RE: Commentor's Letter Memorandum of Technical Comments – in re:

Lehigh Southwest Cement Co. - Pemanente Plant - Site #A0017
Major Facility Title V Operating Permit Renewal

3 *Technical Comments of West Valley Citizens Air Watch and Alex J. Sagady & Associates for Filing with the BAAQMD in Regard to the Lehigh Southwest Cement Company Title V Renewal Application, Draft Operating Permit and Statement of Basis*

Exhibit #5

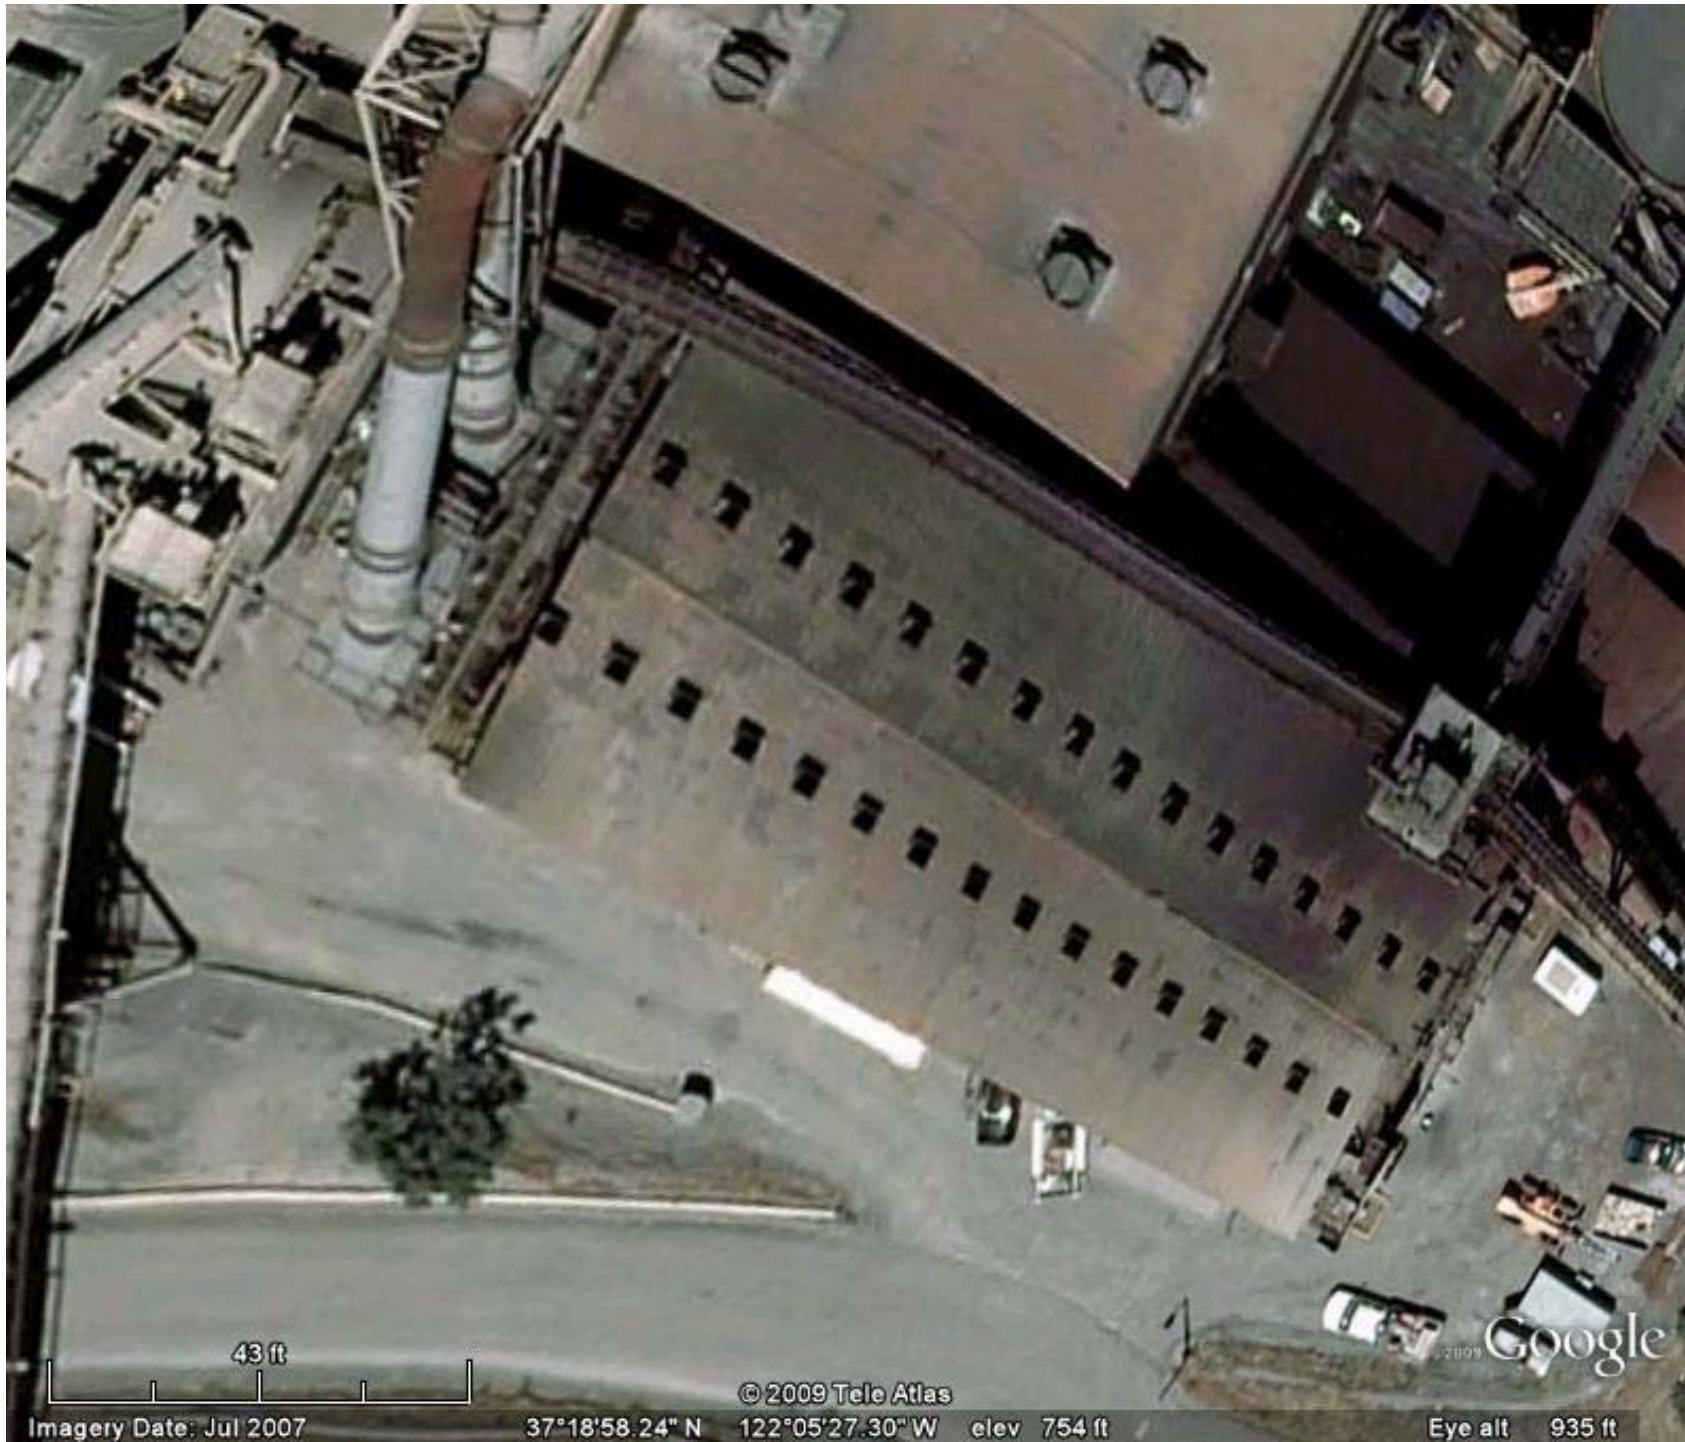
Exhibits #4 and #5 show two materials handling/storage areas visible in aerial photographs of the site which do not appear to be listed as fugitive emission units. Exhibit #4 shows a site adjacent to the clinker storage building and Exhibit #5 shows what appears to be a millscale/iron ore material handling site on the west side of the facility.
